Planning Division Staff Report Planning Commission Meeting

May 11, 2023

ITEM 6.3: Design Review Permit, Tentative Parcel Map – 1751 Pleasant Grove Bl. – NRSP PCL WW-40 - Grocery Outlet – PL22-0205

Figure 5: Proposed Site Plan

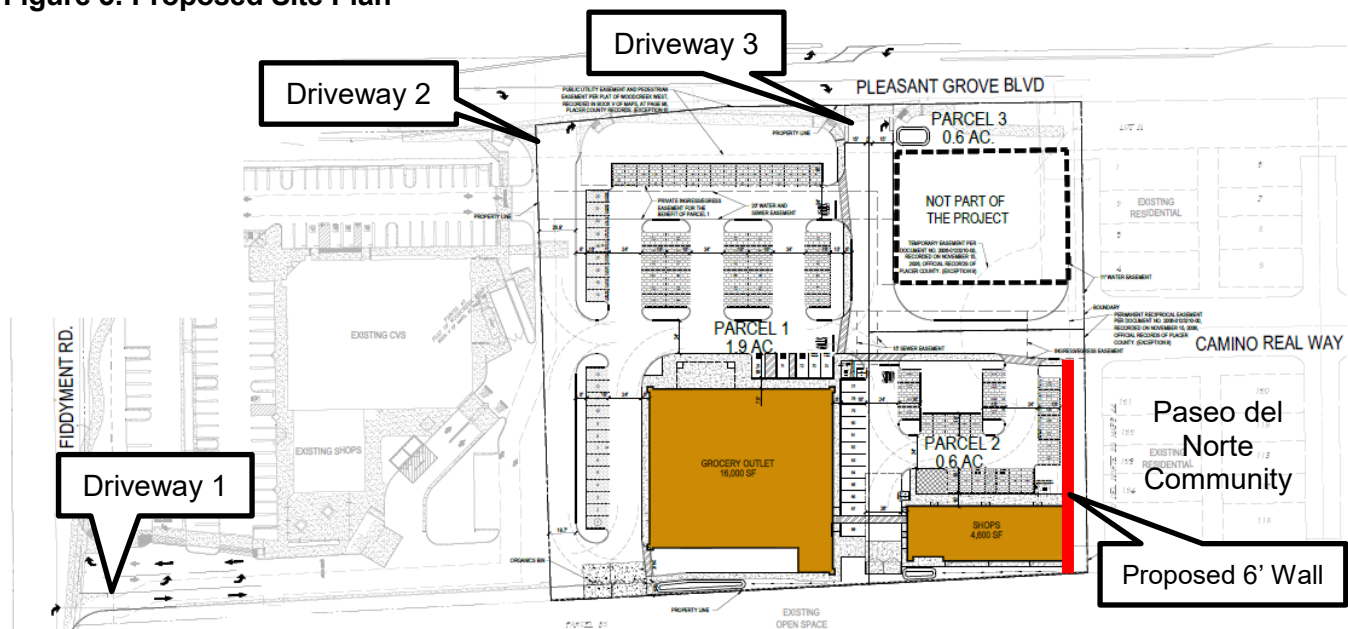
The proposed project including Grocery Outlet and the shops building on parcels 1 and 2, respectively, will be developed in one phase (Figure 5). Parcel 3 will be developed at a later time. The Grocery Outlet and Shops buildings are proposed to be sited closest to the southern property line, which is adjacent to Open Space parcel WW-85 and the WAPA power line corridor. The rear setback for the Grocery Outlet ranges from approximately 10'-35' and the rear setback for the Shops building ranges from approximately 10'-15'. The buildings will be set back approximately 200 feet from the front property line along Pleasant Grove Blvd. The Paseo del Norte community borders the site to the east. The Shops building is proposed approximately 16' from the east property line and approximately 45' from the wall of the nearest homes within Paseo del Norte. The Shops building is oriented to side-on to the residences to the east in order to limit building area exposed to the adjacent residences. There are no doors or windows proposed on the east elevation of the Shops building. Instead, three green screen panels are proposed facing the residences to limit activity on this portion of the site. Furthermore, consistent with the CDG, a 6' masonry wall with a length of

approximately 150' is proposed along the eastside of the project from the southern property line to Camino Real Way. The wall is proposed directly behind the existing curb for the drive aisle in front of the residences.

71. The retaining wall on the south side of the Grocery Outlet loading dock shall be modified to include an additional 6' of height for a total of 10' of wall. (Planning)

72. A second line of trees shall be included along Pleasant Grove Blvd. consistent with the NRSP street tree guidelines. (Planning)
73. The lighting plans shall be modified to include maximum pole heights of 15' in the parking area adjacent to the shops building and 20' maximum adjacent to the Grocery Outlet.
